Addendum No. 6

**ITB No. 24-15
COURTESY PARKWAY EXTENSION FROM
FLAT SHOALS RD TO OLD COVINGTON**

October 2, 2024

ROCKDALE COUNTY, GEORGIA	
PROJECT #:	PI0006934
PROJECT:	Courtesy Parkway Extension from Flat Shoals Rd to Old Covington Hwy
BID NUMBER:	24-15

TYPICAL SECTIONS			
COURTESY PARKWAY EXTENSION			
ROCKDALE COUNTY			
CHECKED:	DATE:	DRAWING No.	
BACKCHECKED:	DATE:	05-0001	
CORRECTED:	DATE:		
VERIFIED:	DATE:

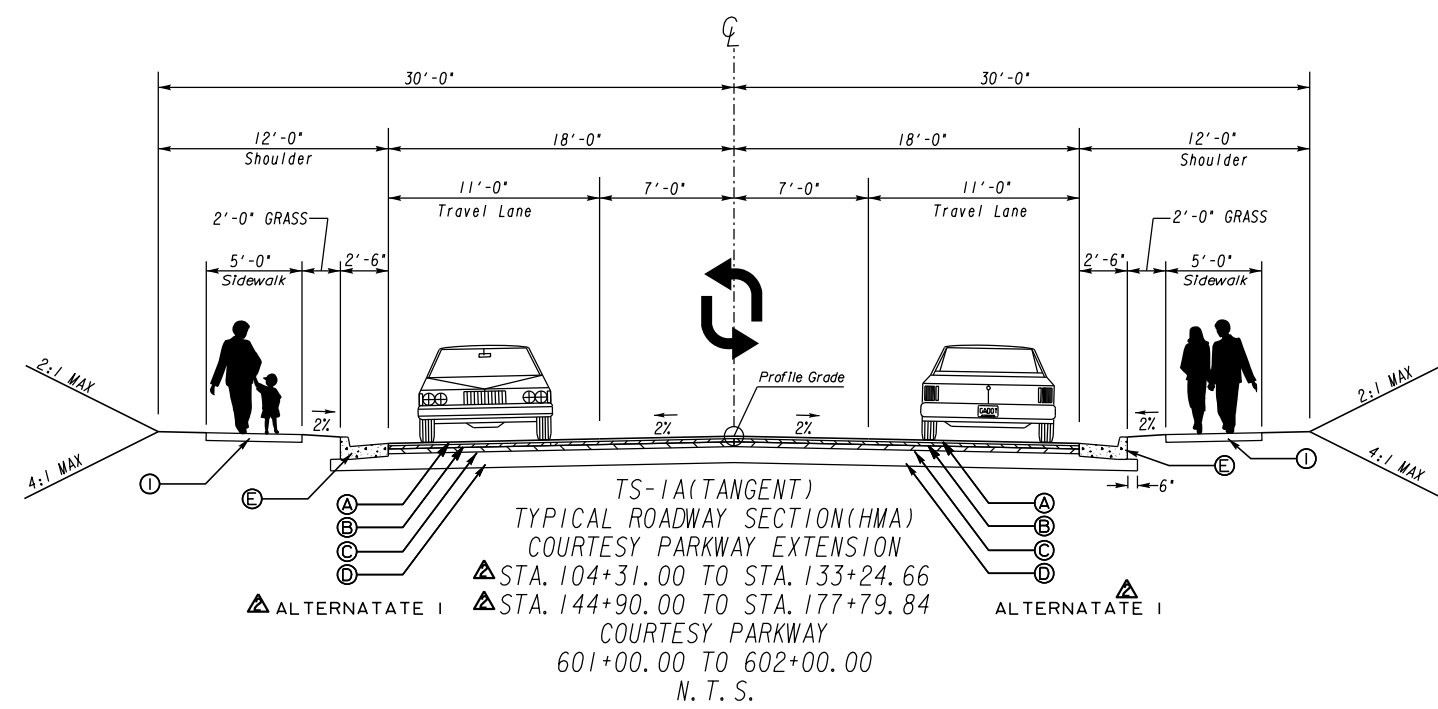
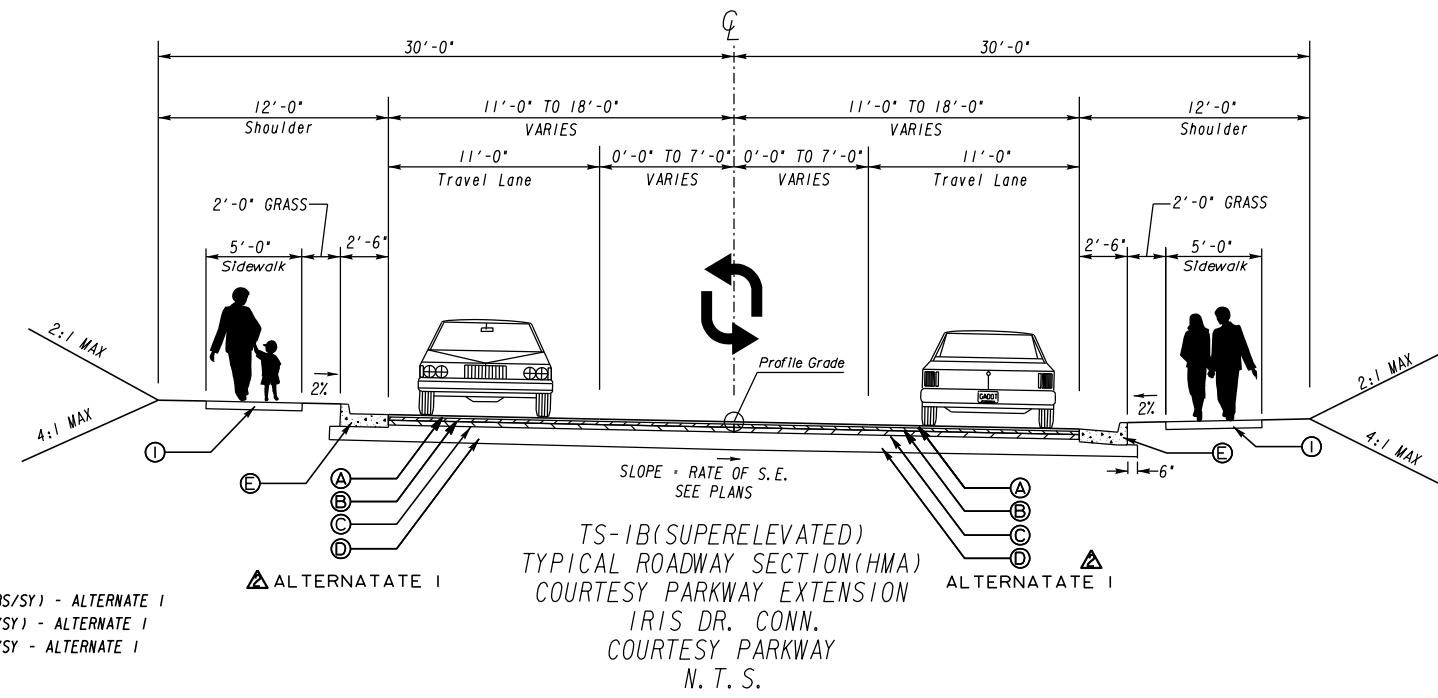
3. **Below are statements clarifying the revisions attached:**
 - **Typical sections (05 series sheets) have been revised to clarify the intent of the contractor to choose between two paving alternatives for Courtesy Parkway. The bid schedule has been revised to show quantities labeled “ALTERNATE 1” and “ALTERNATE 2”. The contractor shall include quantities for either “ALTERNATE 1” or “ALTERNATE 2” in their bid, but not both.**

- Ⓐ RECYCLED ASPH CONC 12.5MM SUPERPAVE, GP 2 ONLY, INCL BITUM MATL & H LIME (165 LBS/SY) - ALTERNATE 1
- Ⓑ RECYCLED ASPH CONC 19MM SUPERPAVE, GP 1 OR 2, INCL BITUM MATL & H LIME (220 LBS/SY) - ALTERNATE 1

- ⓔ PLAIN PC CONCRETE PAVEMENT, 8.0 INCHES - ALTERNATE 2
- ⓕ GRADED AGGREGATE BASE COURSE (18") - ALTERNATE 2
- ⓖ PAVEMENT SAFETY EDGE, SEE GDOT CONSTRUCTION DETAIL P-7

CONSTRUCTION STAGING PLAN		
COURTESY PARKWAY EXTENSION		
STAGE I		
CHECKED:	DATE:	DRAWING No.
BACKCHECKED:	DATE:	19-0024
CORRECTED:	DATE:	
VERIFIED:	DATE:

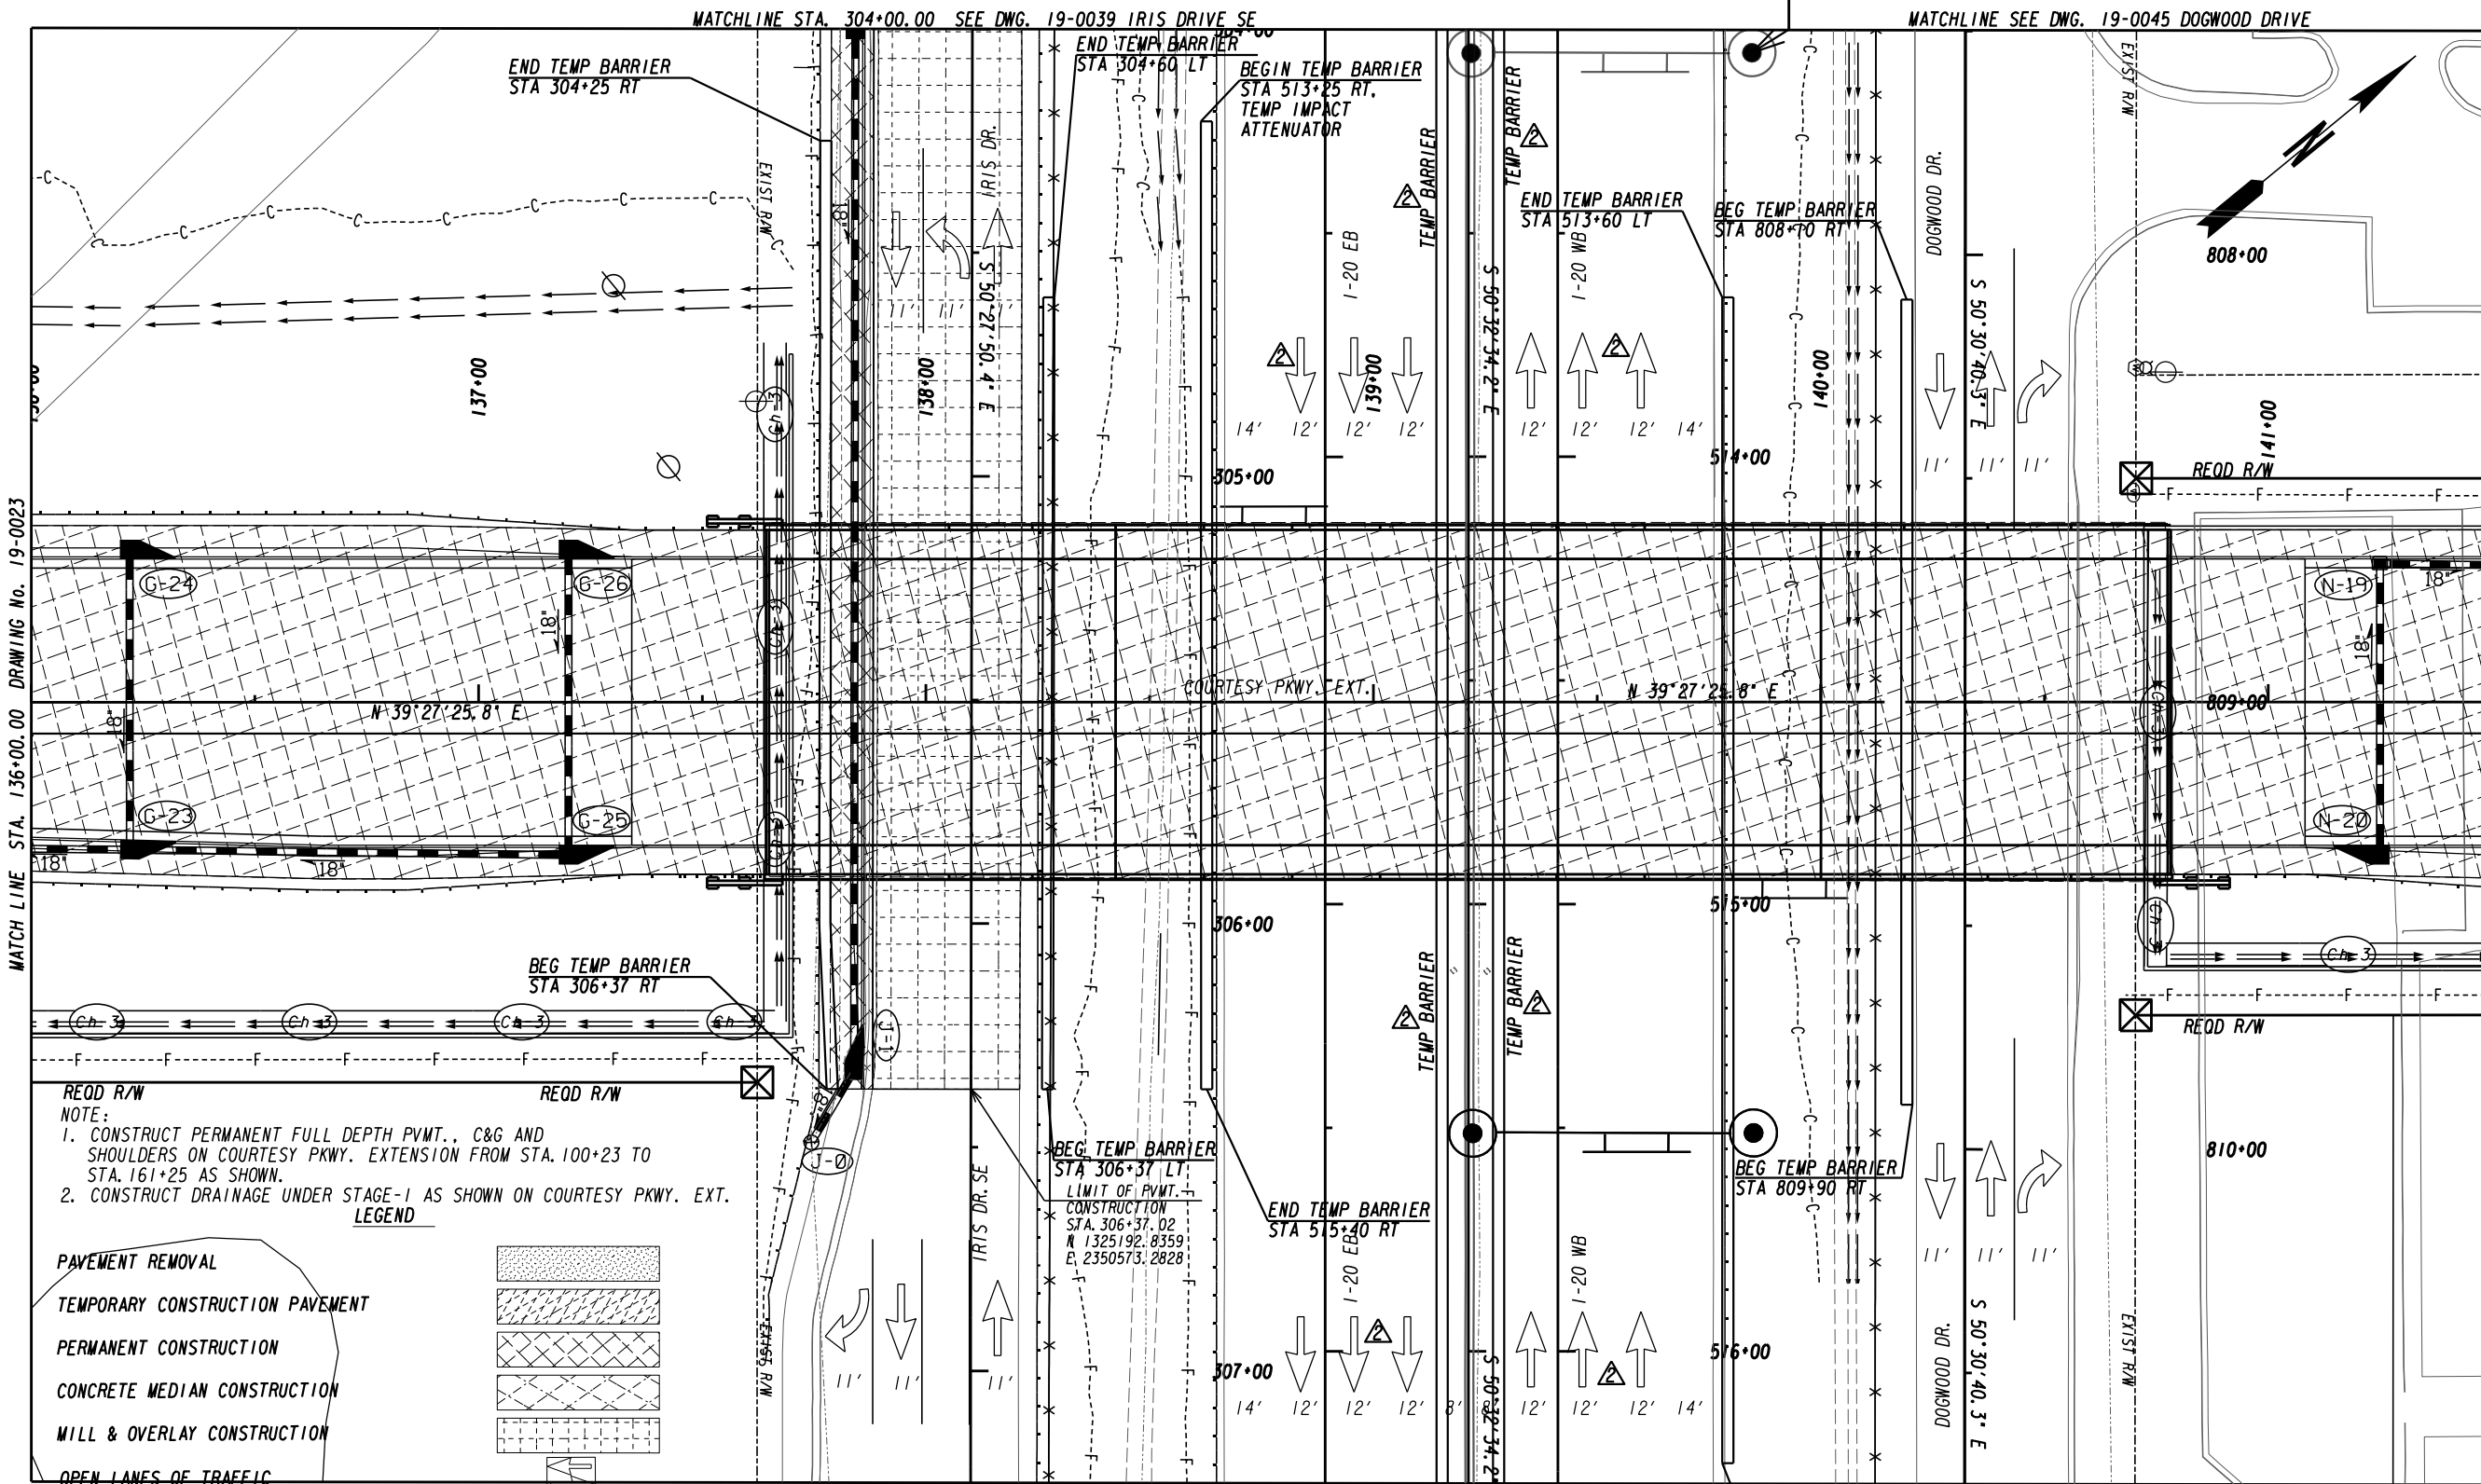
- **Staging plans (19 series sheets) have been revised to show the position of the temporary barrier without time restrictions. As noted in special provision 150.6, temporary barriers may be used for closure of inside shoulders as needed to reconstruct the concrete median barrier on I-20. Temporary barriers may only be used for single inside lane closures at the times specified in Special Provision 150.6. Special provisions 150.6 and 108.08 have also been revised to include double lane closures in the specified times only to allow for protective platform work. Contractors shall follow guidance in Special Provisions 150.6 and 108.08**
